**RE: Revised Work Plan for Additional Soil and Groundwater Characterization
Peralta Community College District Maintenance Yard, 501 5th Avenue, Oakland, California
Fuel Leak Case No. RO0000384, GeoTracker Global ID T0600100983
ACC Project Number: 6045.019.02**

Revised Work Plan for Additional Soil and Groundwater Site Characterization

Peralta Community College District Maintenance Yard
501 5th Avenue, Oakland, California

Figure Number: 5	1" = 200'
Project Number: 6045-019.01	Drawn By: IS
 An Employee Owned Company	Date: 6/10/12

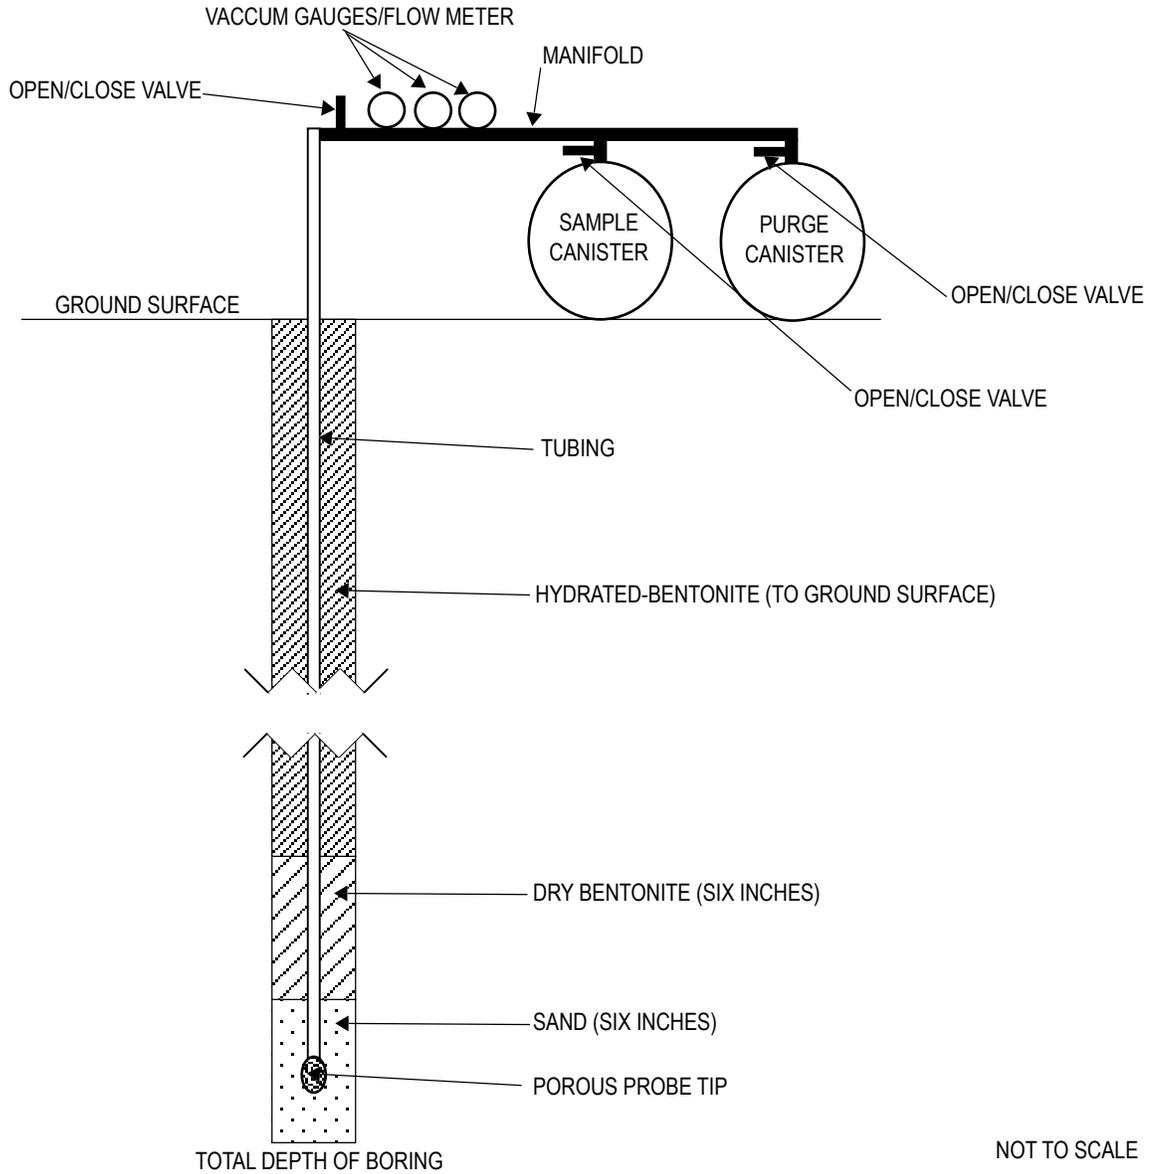
(1) **Proposed Soil Boring Locations.** *The Work Plan proposes five soil borings in the area of existing boring ACC-B-14 and four soil borings in the area of existing borings ACC-B-16 and ACC-B-17. There is no scale shown on the map; however, based on a comparison to other base maps, it appears that the borings are up to 380 feet away from the existing ACC borings. It appears that several of the borings are too far away from the likely source and/or are in cross gradient locations to assess the site. Some of the proposed locations may duplicate previous results from the 1993 investigation. No background information, previous data, or the likely locations of the suspected source(s) are presented to help evaluate the proposed locations. We request the following information be presented in the Revised Work Plan to develop and illustrate proposed soil boring locations:*

- *Base map to include a scale*
- *Base map to include previous boring locations and results from the "Site Investigation Report," dated September 21, 1992 and prepared by Environ*
- *Potential sources identified from previous historical documents are to be shown on the base map and discussed in the text.*

Response: A scaled site map (Figure 5) has been prepared and includes the previous borings conducted by Environ and ACC along with the proposed additional borings and available groundwater data for select petroleum hydrocarbons.

The version of the 1992 Environ Site Investigation Report available to ACC did not contain Figures 1, 2 and 3, which depict the potential sources of the subsurface impacts. Based on the narrative, the area of boring ACC-B-14 was formerly a truck service station and the area of ACC-B-16 and ACC-B-17 was formerly a service station and municipal equipment garages. The groundwater impacts at ACC-B-16 and ACC-B-17 are referred to as Plume B.

(3) **Soil Vapor Sampling.** *Section 3.3 includes references to soil vapor sampling and sub-slab sampling. The depth of the proposed soil vapor samples is not discussed. Please revise this section to discuss only the proposed soil vapor sampling methods. Please discuss purging in terms of purge volumes in which one purge volume equals the internal*

volume of the tubing, the void space of the sand pack around the probe tip, and volume of dry bentonite in the annular space. Please provide a diagram showing the proposed construction of the vapor probes. Please also clarify whether a shut in test will be performed.

Response: Soil vapor sampling is discussed in Section 5.3, below. Included in the discussion are depths, purging volumes and the proposed shut-in test methodology. A diagram showing the proposed construction of the vapor probes is attached as Figure 6.
